ALL CONSTRUCTION GROUP

ADDENDUM NO.: 01
PROJECT NAME: North Park Village (NPV) Administration-Building C (Bid Package 1 – Campus Signage)
PROJECT NO.: 04038
DATE OF ISSUE: 6/8/2023

NOTICE OF CHANGES, MODIFICATIONS, OR CLARIFICATIONS TO CONTRACT DOCUMENTS

CAMPUS SIGNAGE PACKAGE ADDENDUM #1 2023.06.07

ENTRY SIGNAGE DETAILS

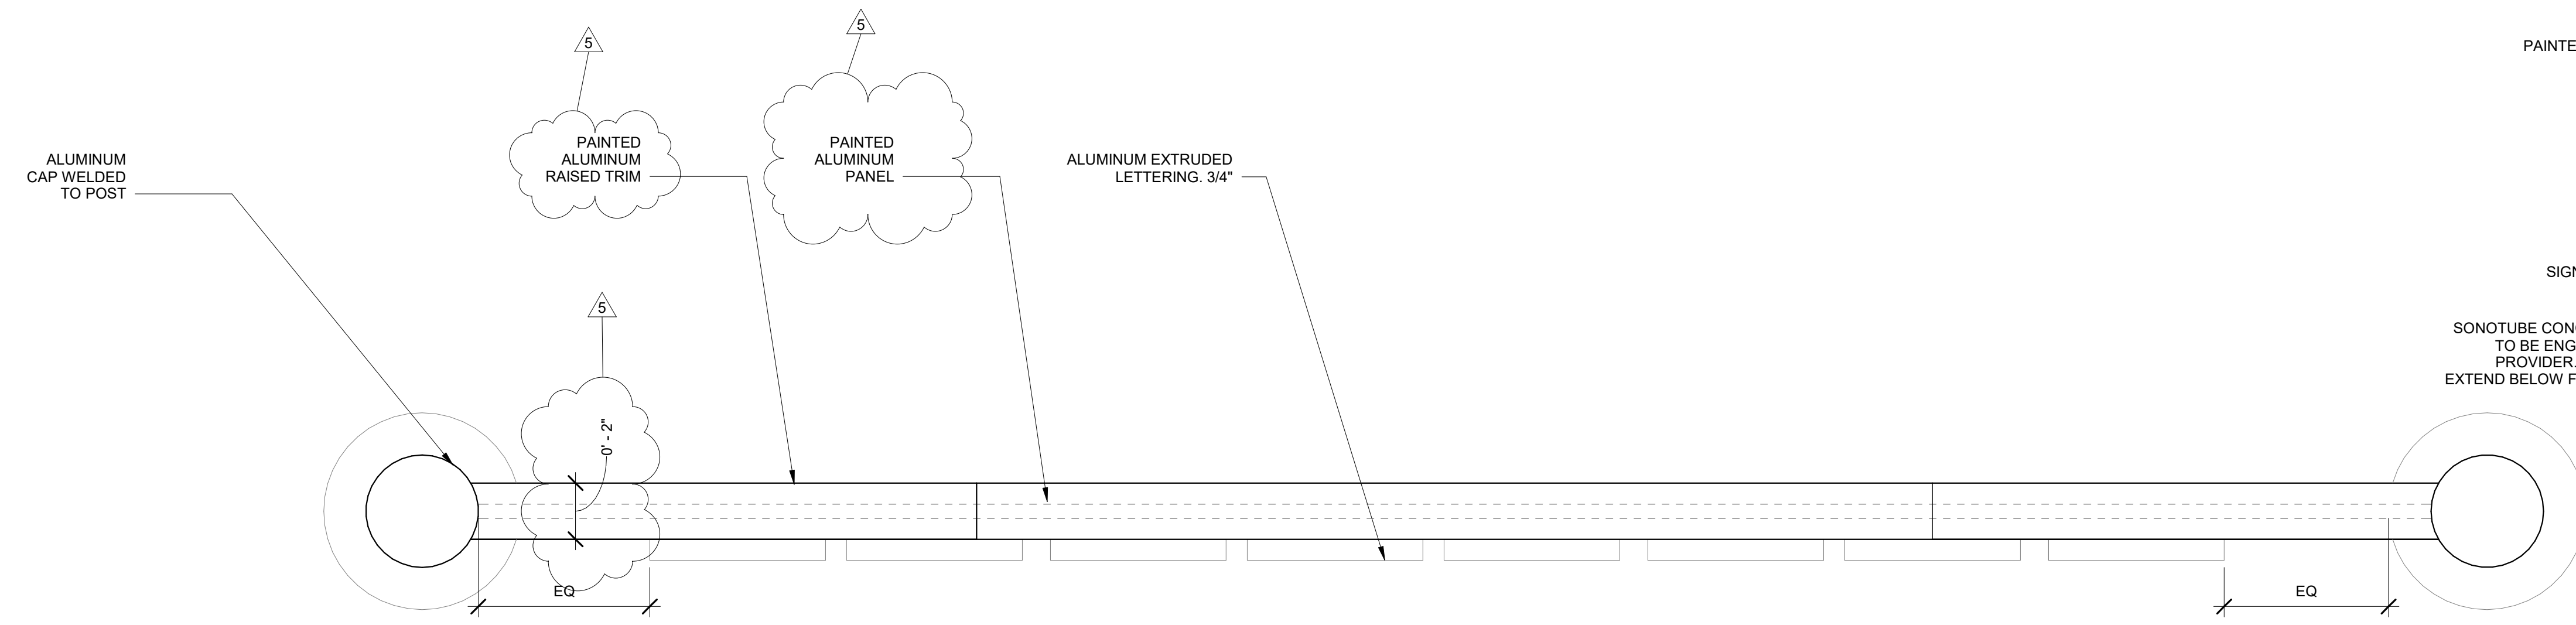
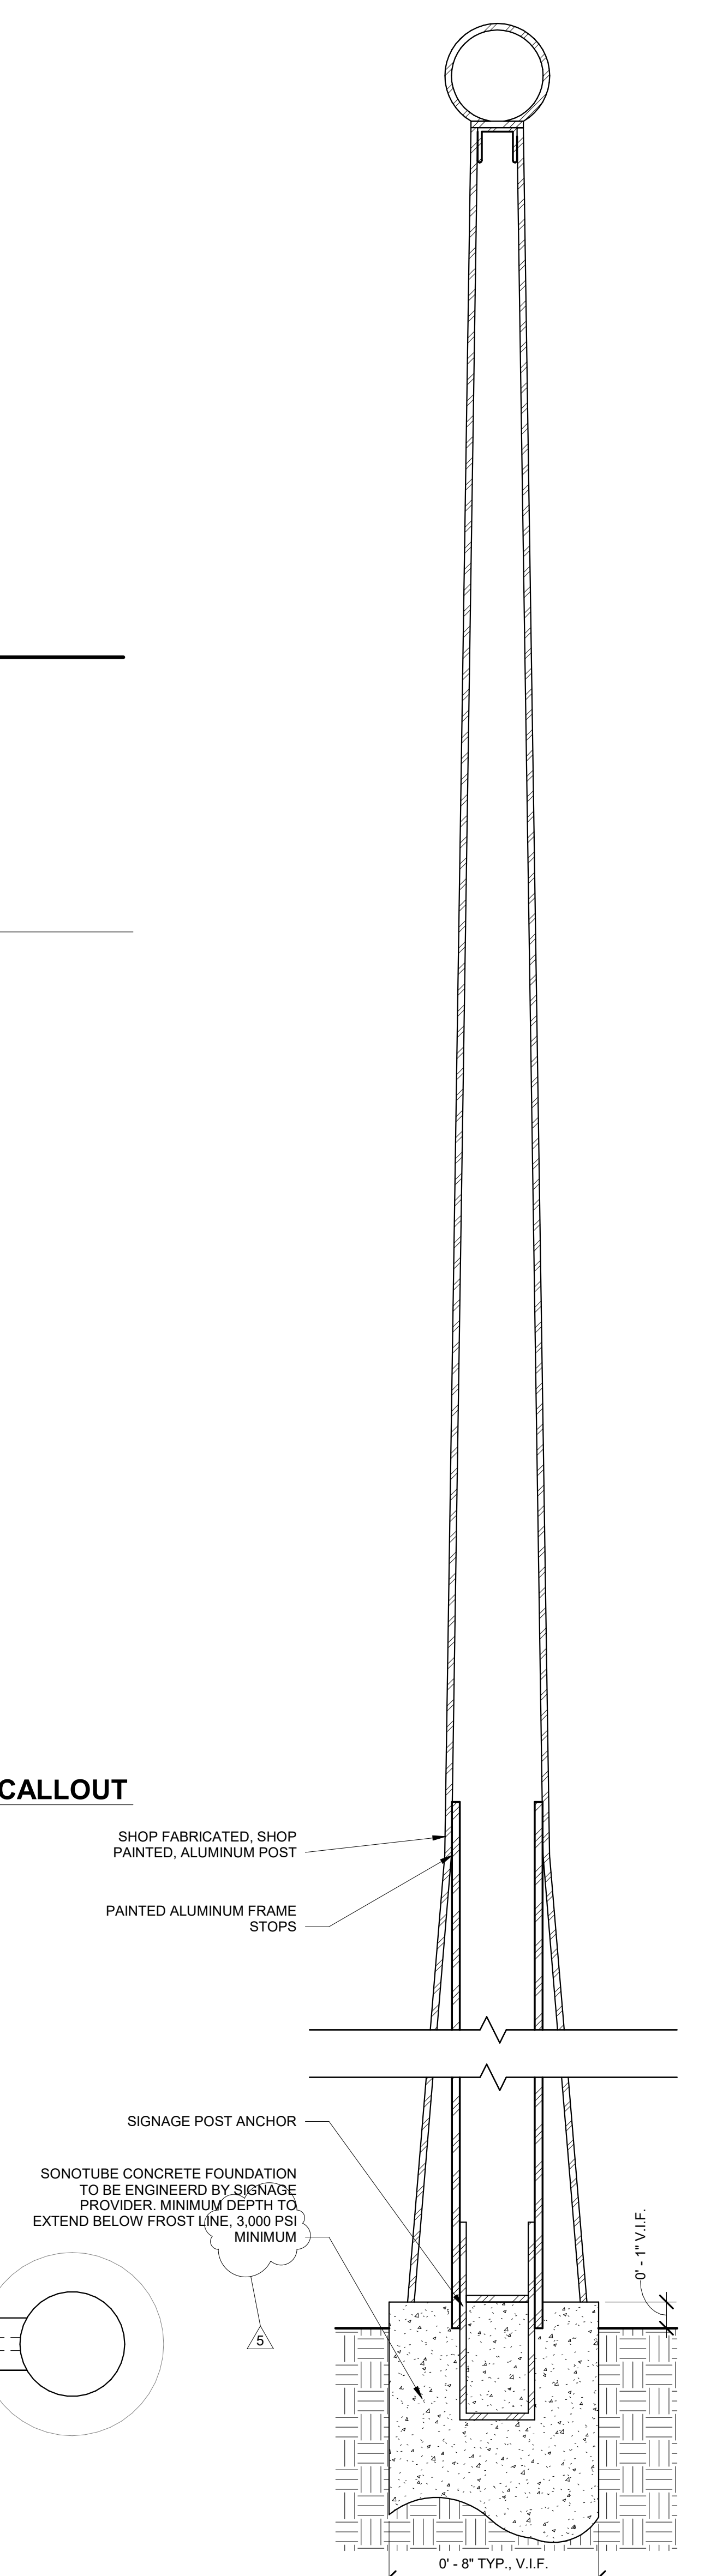
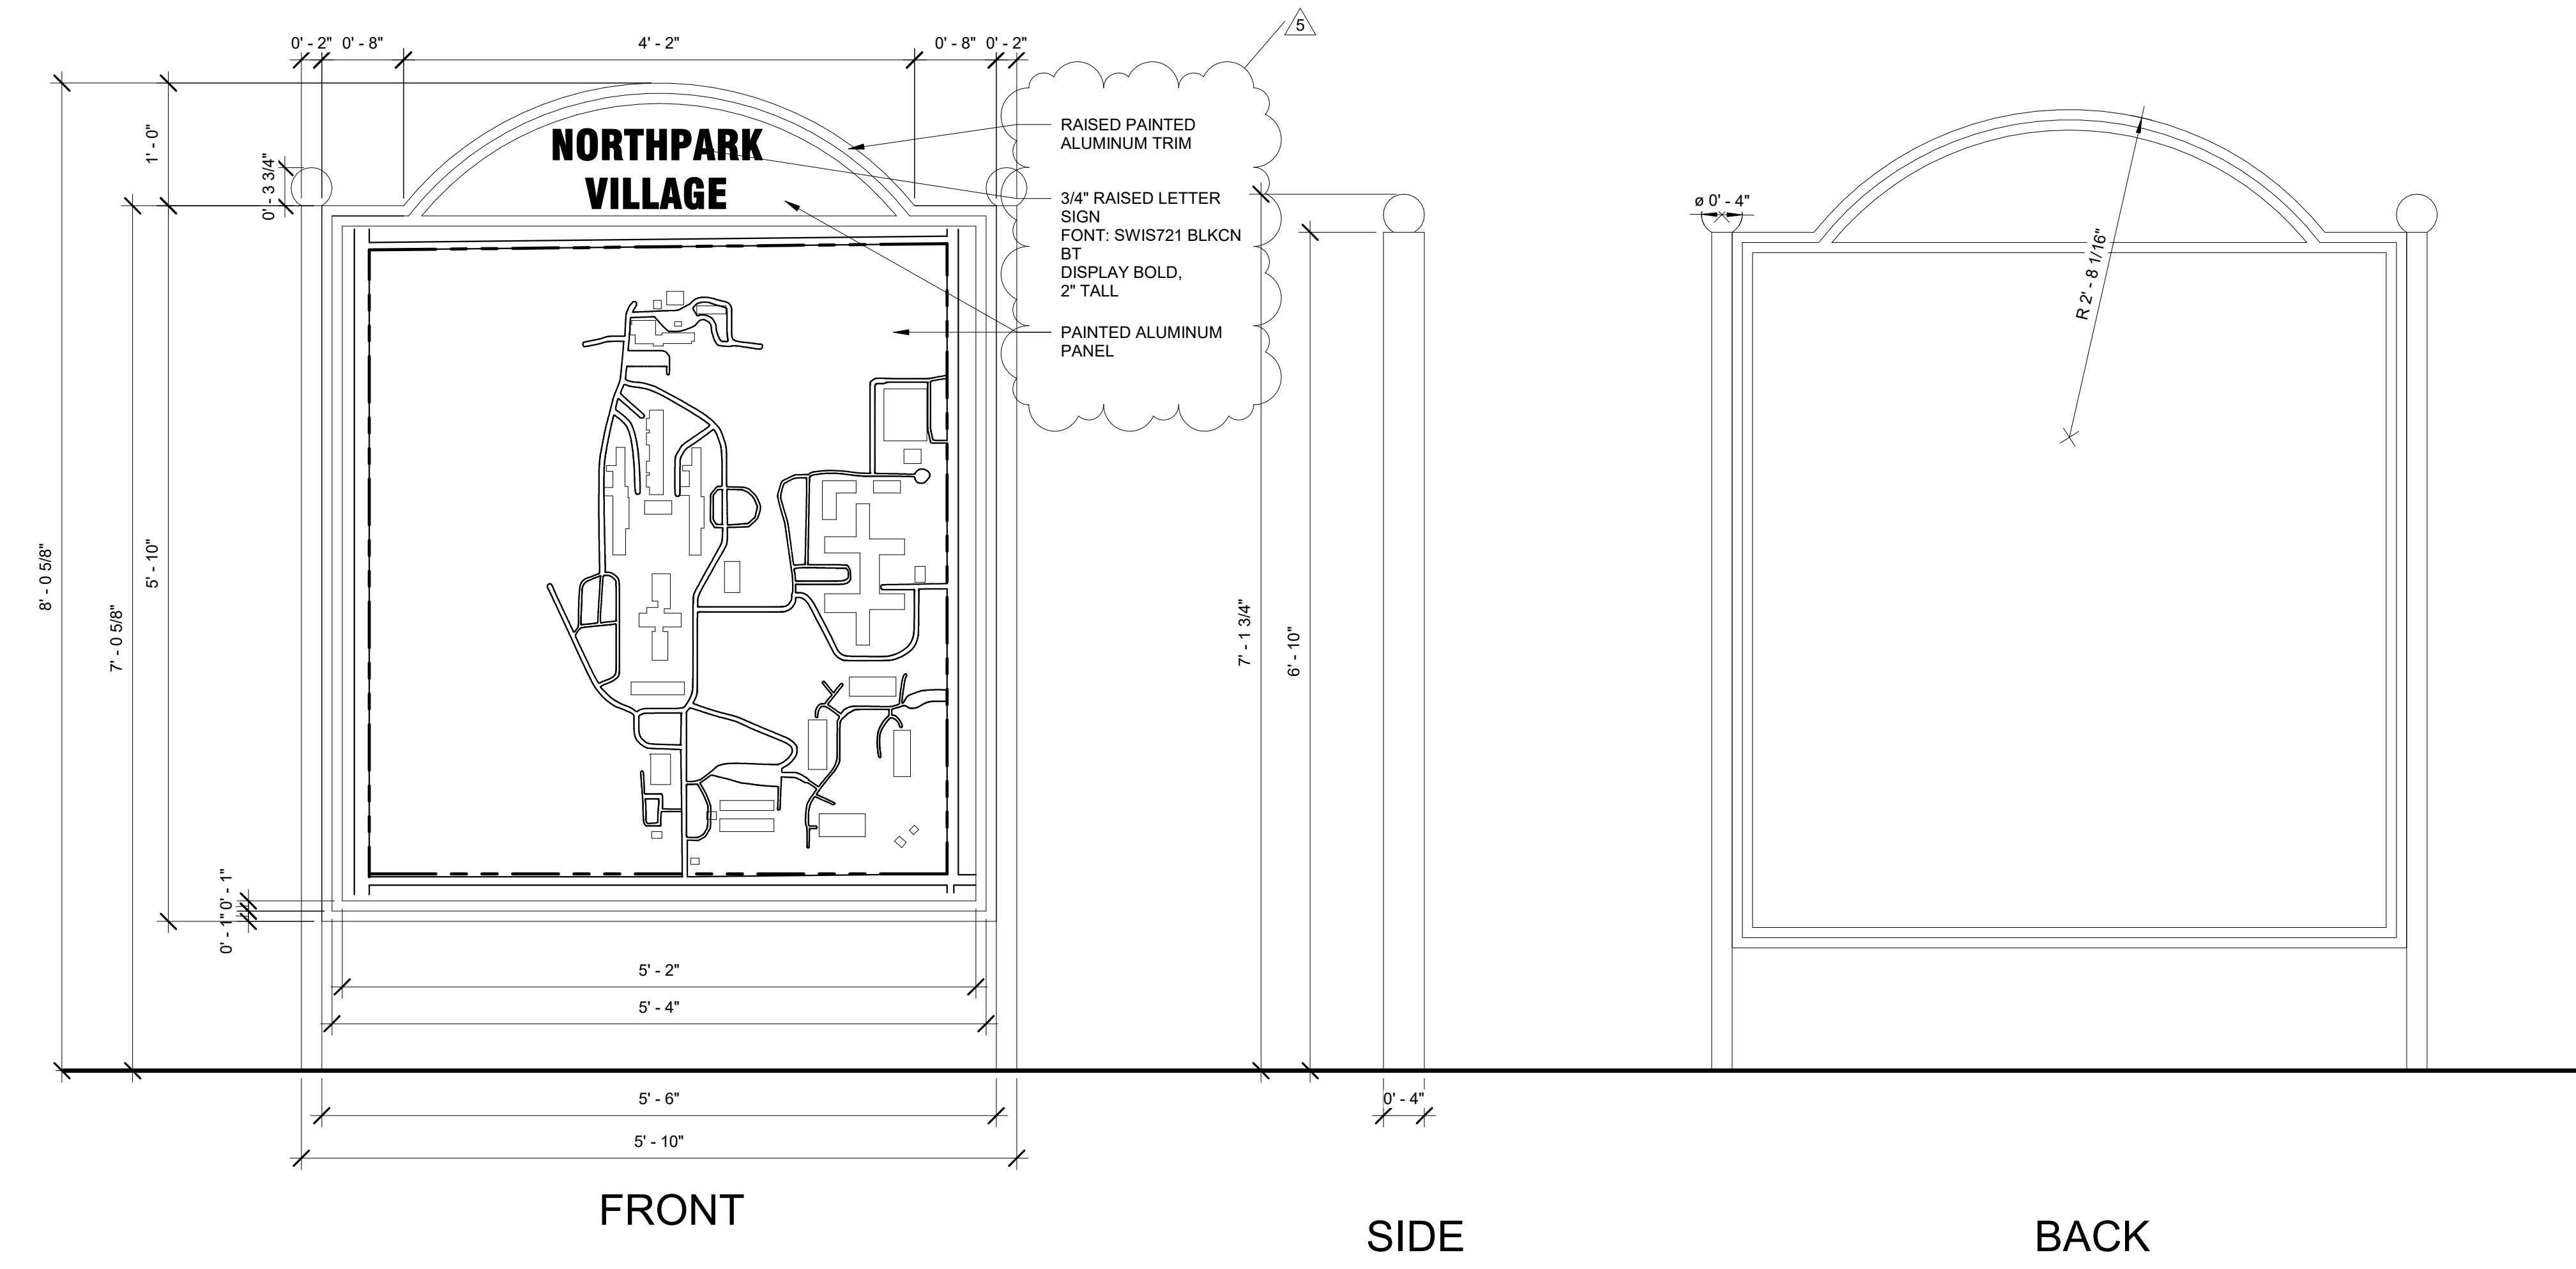
Change 3 **Revised** A-901, added notes regarding Aluminum Back Panel, Concrete Footing PSI, and Trim.

Question 2 We have gone through the drawings and are currently pricing everything. There is no information on the backer panel all the letters / maps are installed on. Do you have any more info or should

we make some assumptions? In addition, the letters are called out at $\frac{3}{4}$ " thick which is expensive, any interest in going to $\frac{1}{4}$ or $\frac{1}{2}$ to save money?

Answer: Back panels are to be painted aluminum. Letters are to be $\frac{3}{4}$ " thick as indicated on the Contract Documents. Please refer to revised Sheets A-901 and A-902.
